Project	<b>IEEE 802.16 Broadband Wireless Access Working Group</b> < <a href="http://ieee802.org/16">http://ieee802.org/16</a> >	
Title	<b>Corrections on MS network entry procedures in transparent RS systems</b>	
Date Submitted	<b>2007-07-05</b>	
Source(s)	Kanchei (Ken) Loa, Yi-Hsueh Tsai, Yung-Ting Lee, Hua-Chiang Yin, Shiann-Tsong Sheu, Youn-Tai Lee,  Institute for Information Industry 8F, No. 218, Sec. 2, Dunhua S. Rd., Taipei City 106, Taiwan	Voice: +886-2-27399616 Fax: +886-2-23782328 <a href="mailto:loa@nmi.iii.org.tw">loa@nmi.iii.org.tw</a>
Re:	IEEE 802.16j-07/019: "Call for Technical Comments Regarding IEEE Project 802.16j"	
Abstract	This contribution proposes corrections on MS network entry procedures in transparent RS systems.	
Purpose	Text proposal for 802.16j Baseline Document.	
Notice	<i>This document does not represent the agreed views of the IEEE 802.16 Working Group or any of its subgroups. It represents only the views of the participants listed in the "Source(s)" field above. It is offered as a basis for discussion. It is not binding on the contributor(s), who reserve(s) the right to add, amend or withdraw material contained herein.</i>

# Correction on MS network

Figure 95c—Handle CDMA initial ranging code in transparent mode at MR-BS

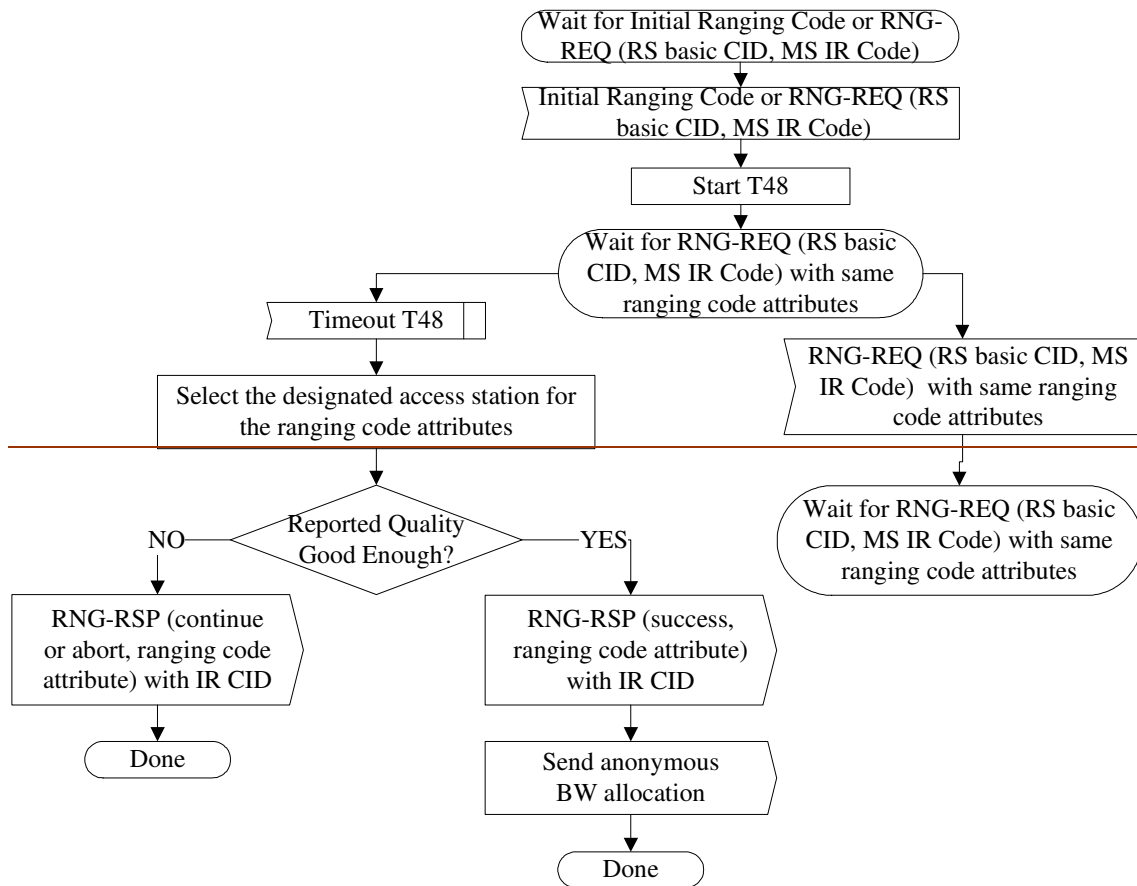
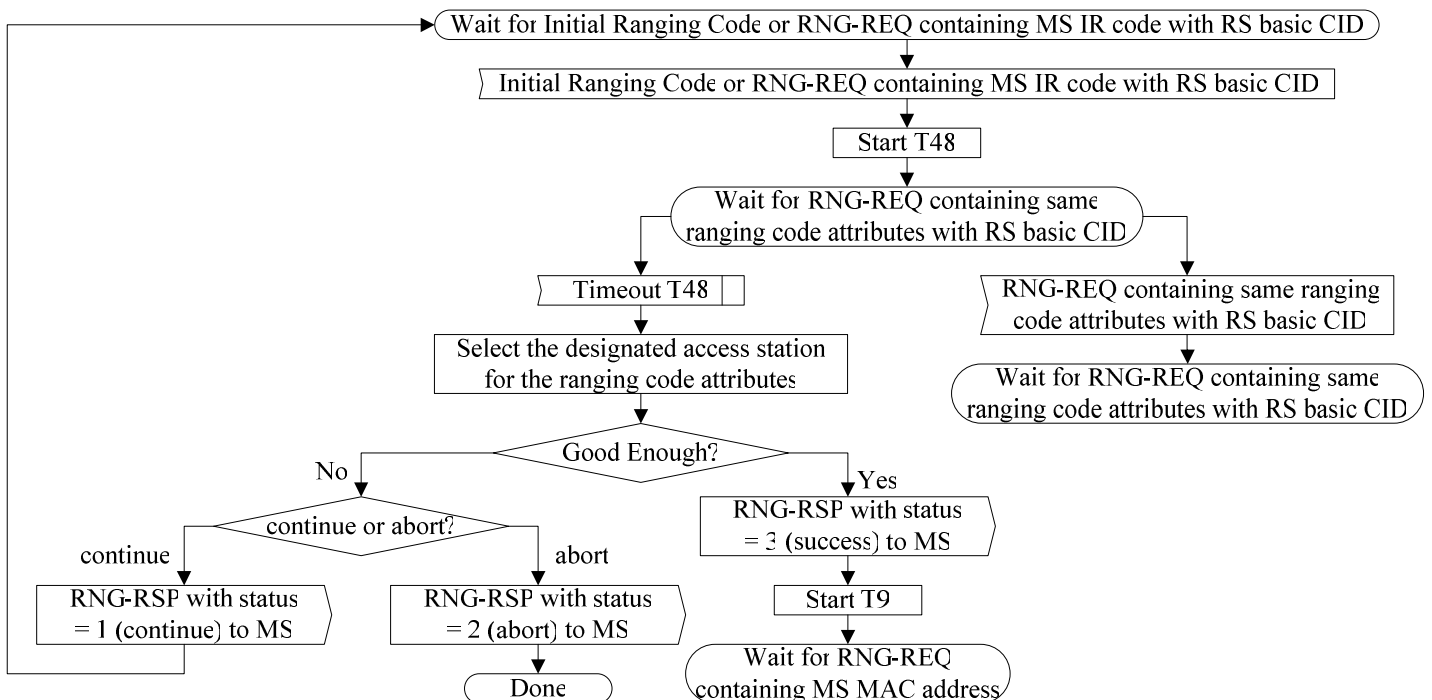
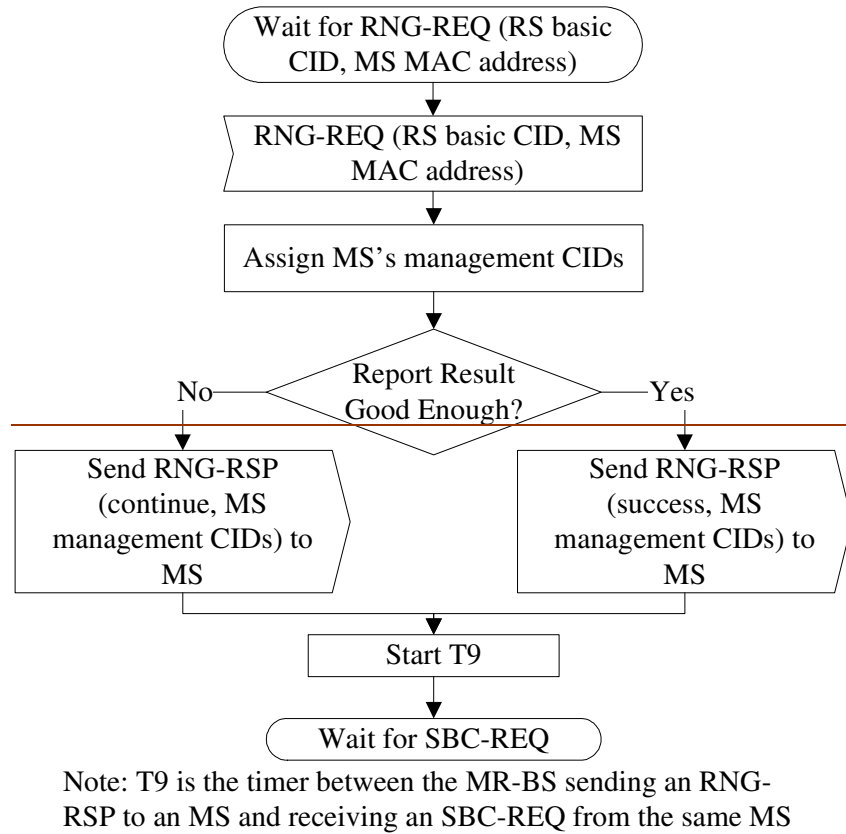
[Replaced the figure 95c in page 81 as following indicated]

Figure 95d—Handle RNG-REQ in transparent mode at MR-BS

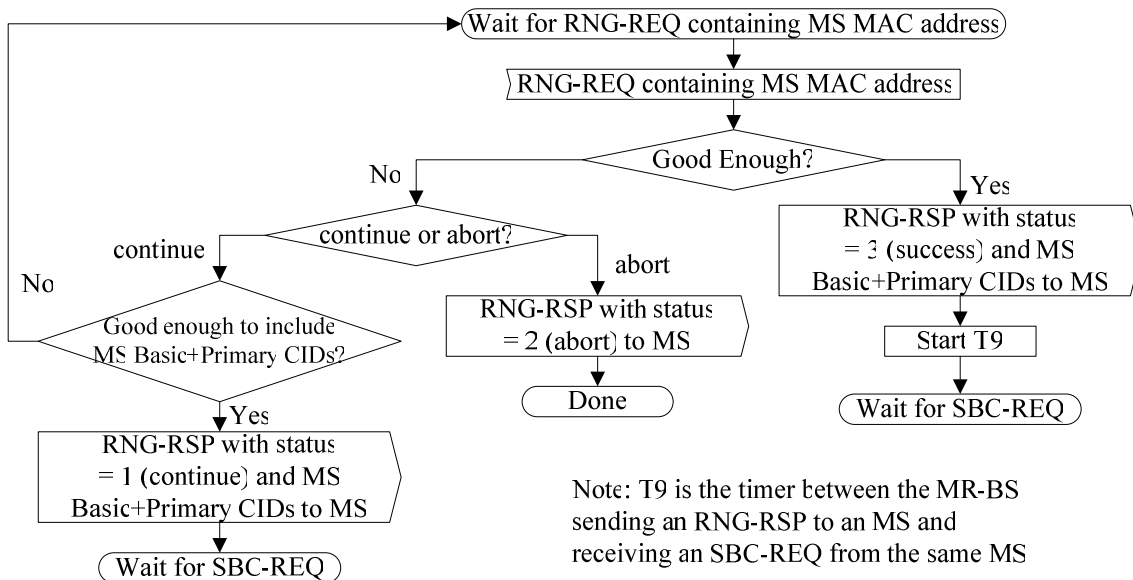
[Replaced the figure 95d in page 82 as following indicated]

~~Figure 95d—MS Initial Ranging with Transparent RS—MR-BS~~
